## LAKE NONA TOWN PHASE 1B AMENDMENT

Recommendation of approval for a Specific Parcel Master Plan (SPMP) amendment to increase office development for Building F of the Town Center Phase 1 from 100,000 square feet to 165,000 square feet by adding two (2) floors to the previously approved four (4) story building.

# EXHIBIT A: SITE PLAN

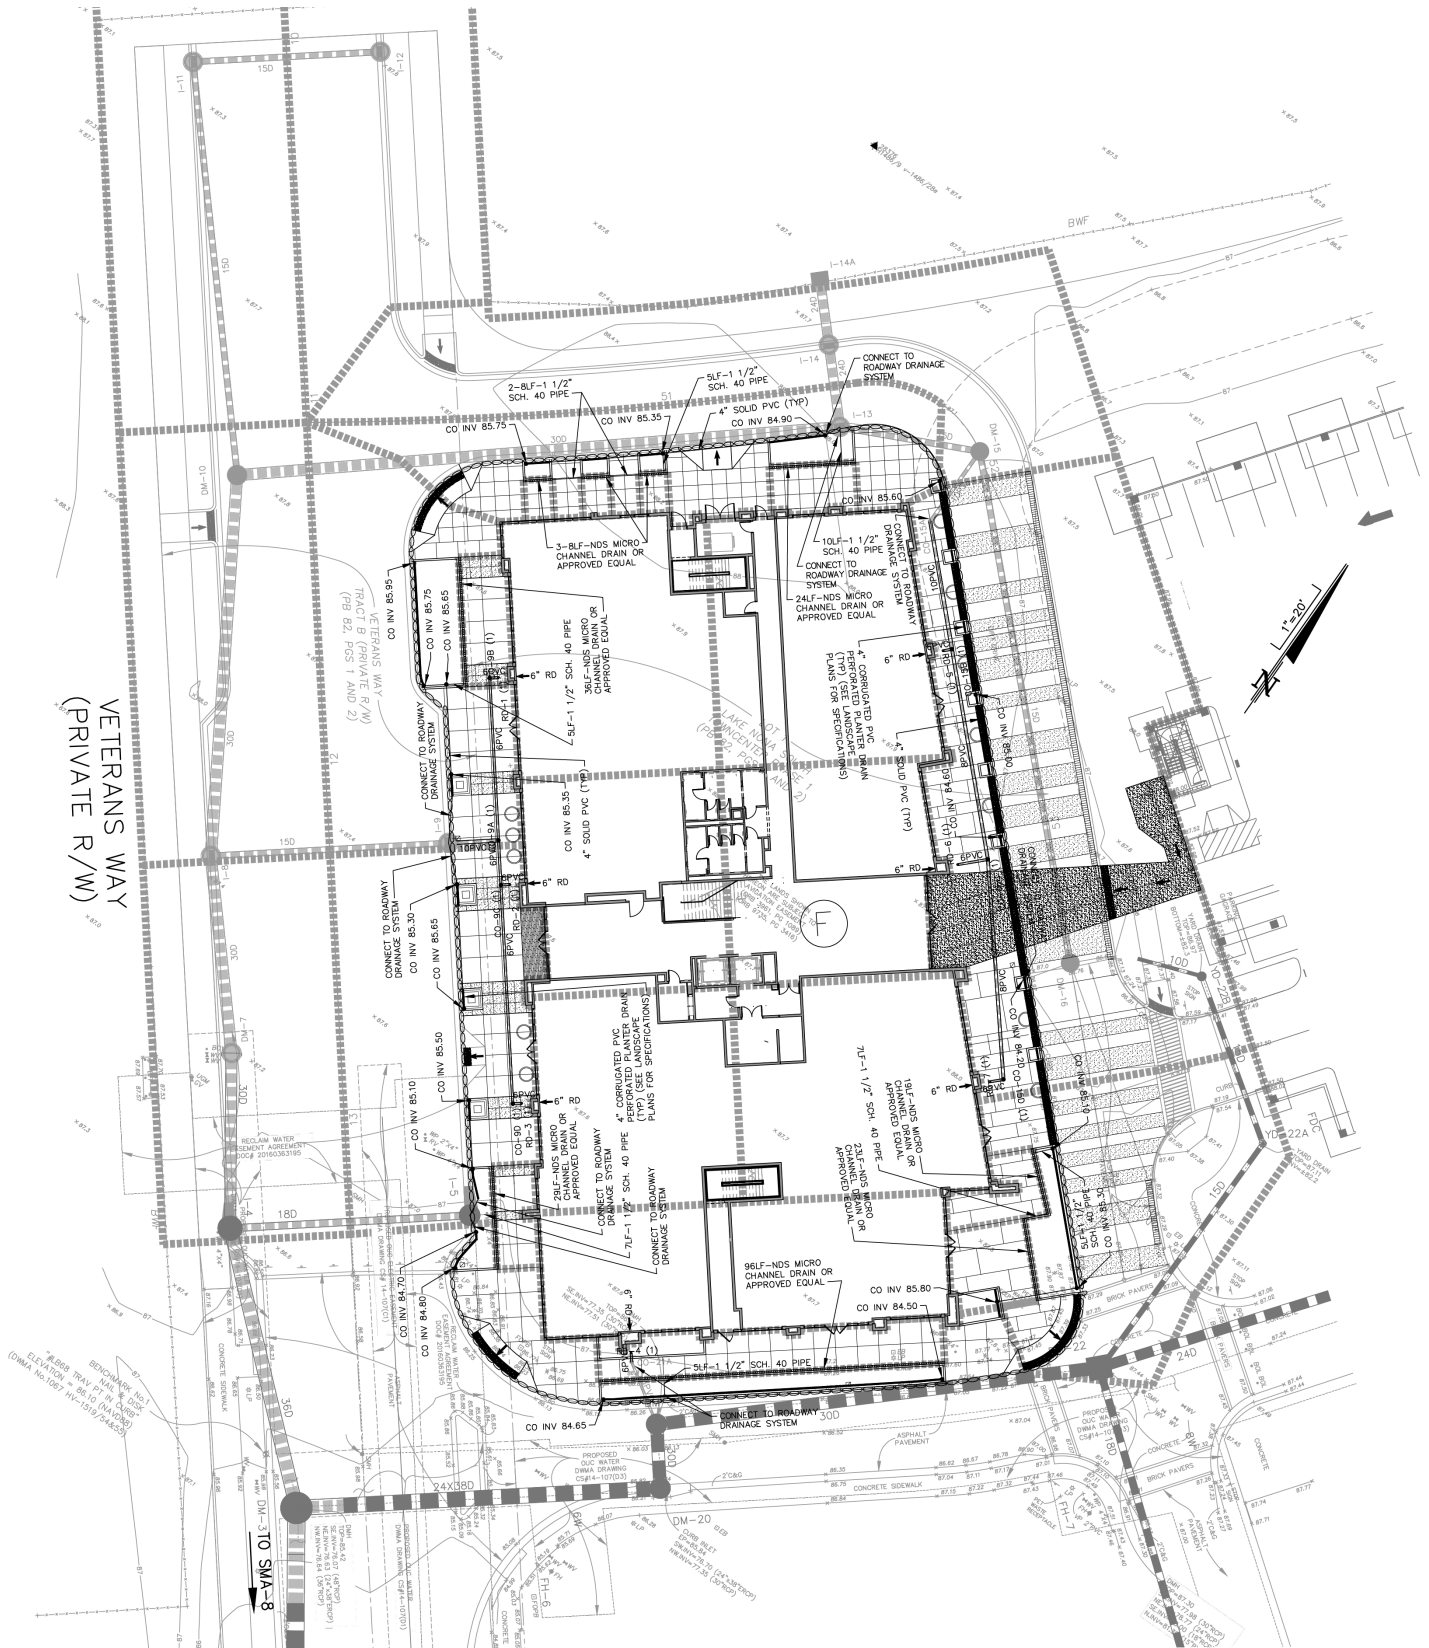
Front Yard and Side Street setbacks shall be no greater than 10 ft. Rear Yard setbacks shall be no less than 10 ft. MPL2013-00019 allows for an alternative standard of a maximum 30 feet from back of curb on Veterans Way. The proposed building is setback 25 ft. from Veterans Way. The rear abuts an internal roadway with a proposed 10 ft. setback.

The subject proposal has a site plan identical to the plans approved through LDC2016-00310 and BLD2016-06481. The main pedestrian crossing areas between buildings and the parking garage shall be clearly marked. In addition, a paved pedestrian/handicap connection and/or sidewalk shall be provided from the public sidewalks to the main building entrances, clearly marked with pavement markings. Handicap accessible ramps shall be constructed at street intersections and driveway connections to comply with ADA. The proposed site plan displays a connected internal sidewalk system consistent with the Master Plan. Maximum sidewalk widths are as follows: 26 ft. to the north, 18 ft. to the east, 23 ft. to the west and 25 ft. to the south. Sidewalk clear zones are as follows: 6 ft. wide to the north, 12 ft. wide to the south, 6 ft. wide to the east and 10 ft. wide to the west.

*Loading areas*—It is required that all loading areas for Building F face the parking garage or western most service road. All loading areas and dumpster areas adjacent to the building shall be screened to appear to be part of the building. The same building materials and architectural details shall be used for the finishes of these areas. Loading areas, too, shall be designed internal to the project. Dumpsters are not permitted to be located on any primary street frontage. They should be built into the building service area, placed adjacent to service road and screened to match principle structure. The service area is proposed to the west along the proposed service road. The dumpster is in an enclosed room on the west side of the building with a curb-cut for removal and service. Materials and finishes are consistent with the rest of the building. Incomplete information was provided as to whether CPTED principles were addressed in this low visibility area.

A site plan must show full crossings meeting ADA standards at all corners including the north-east corner to the garage, east to the proposed Bid. G, and south-east to connect the public realm.

A certificate of occupancy shall not be issued until there is sufficient parking available to serve the proposed use. An additional 264 spaces are needed.

EXHIBIT B: LANDSCAPE PLAN

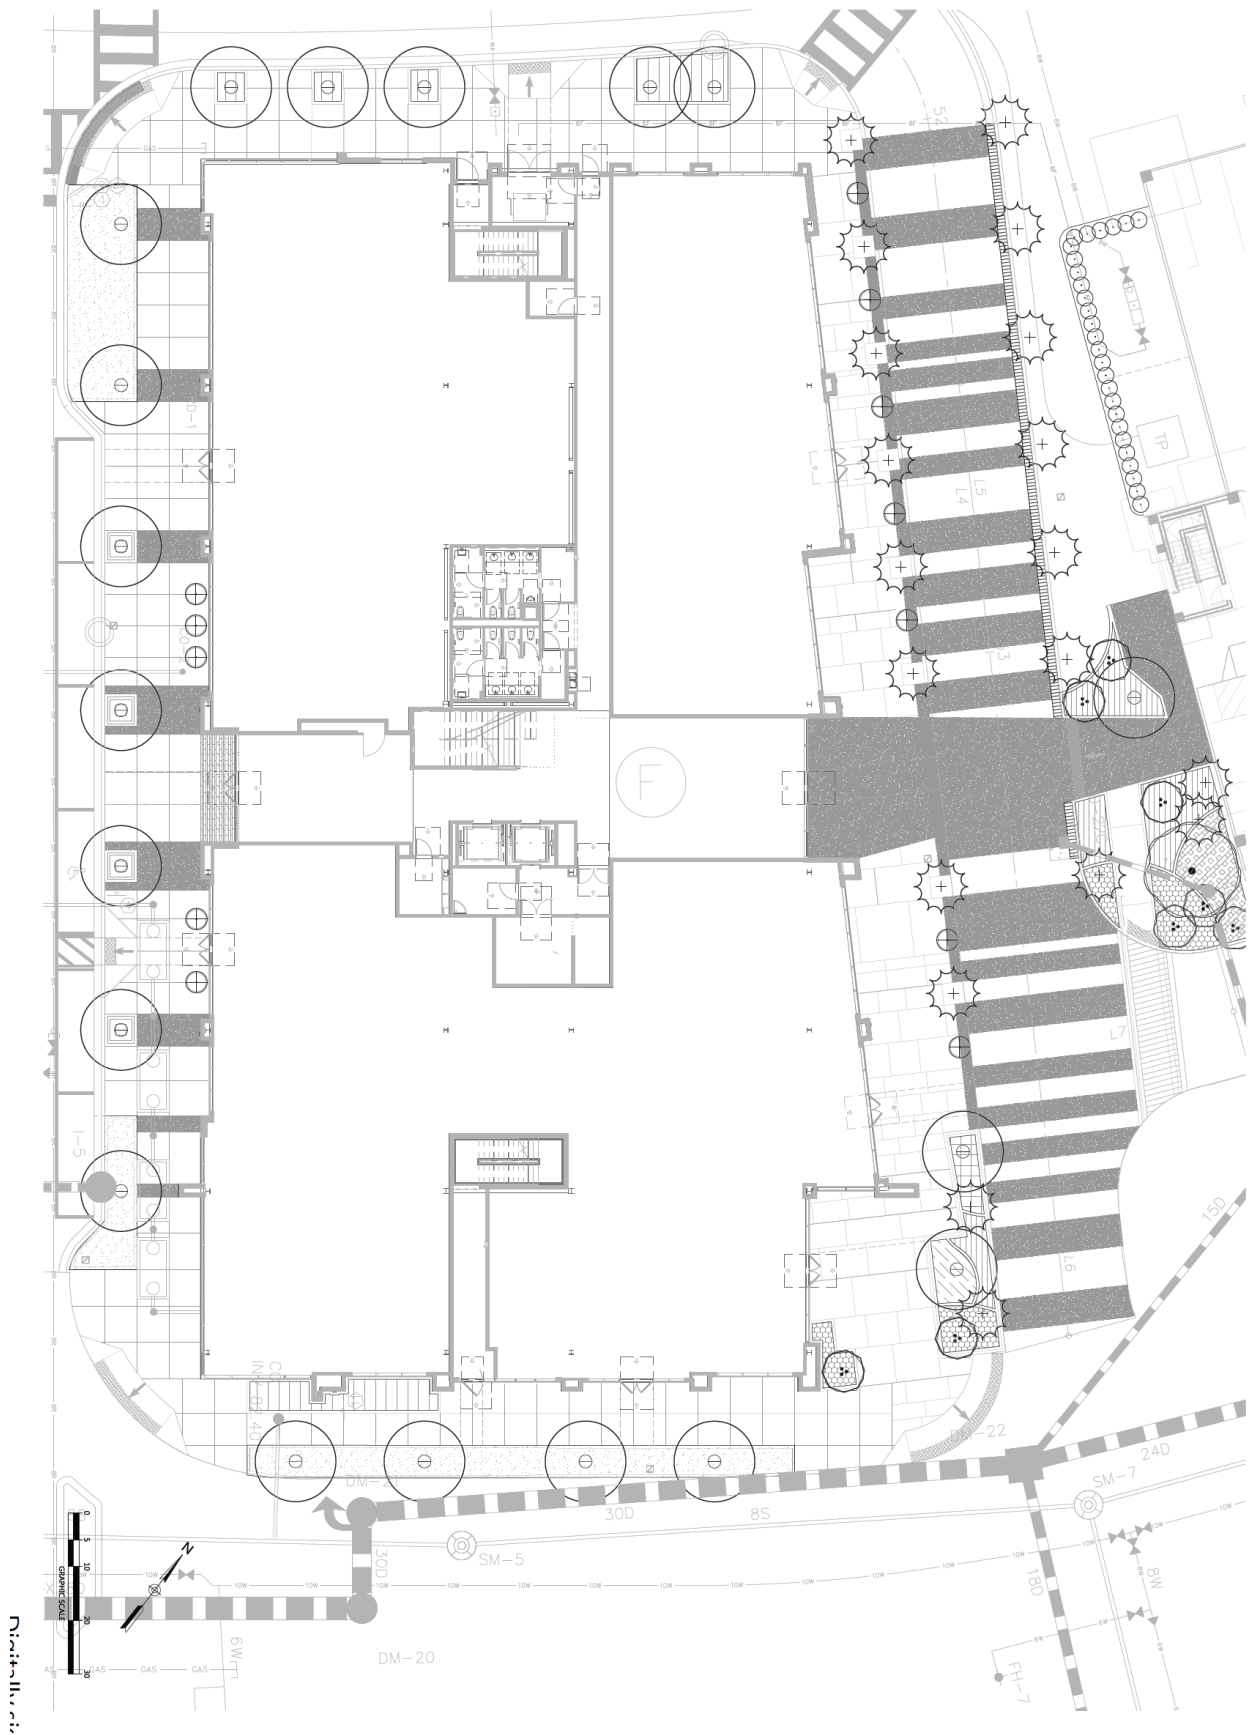
The subject proposal has a landscape/streetscape plan identical to the plans approved through BLD2016-06481. The applicant is required to provide a Minimum Required Landscape Score at time of permitting. Streetscape and street trees along Veterans Way shall be consistent with Tavistock Lakes Blvd. streetscape design.

Streetscape along Veterans Way, including street trees, street lights, plant selection and sidewalks, shall be generally consistent with Tavistock Lakes Blvd. Streetscape should also be consistent with LDC 2014-00028 Revised (April 29, 2014), where a minimum 8 ft. wide sidewalk is required on both sides of Veterans Way. Street trees shall be provided in a park strip adjacent to the curb in locations where on-street parking is not proposed. On-street parking shall be 8 foot wide and allow 2 feet clearances.
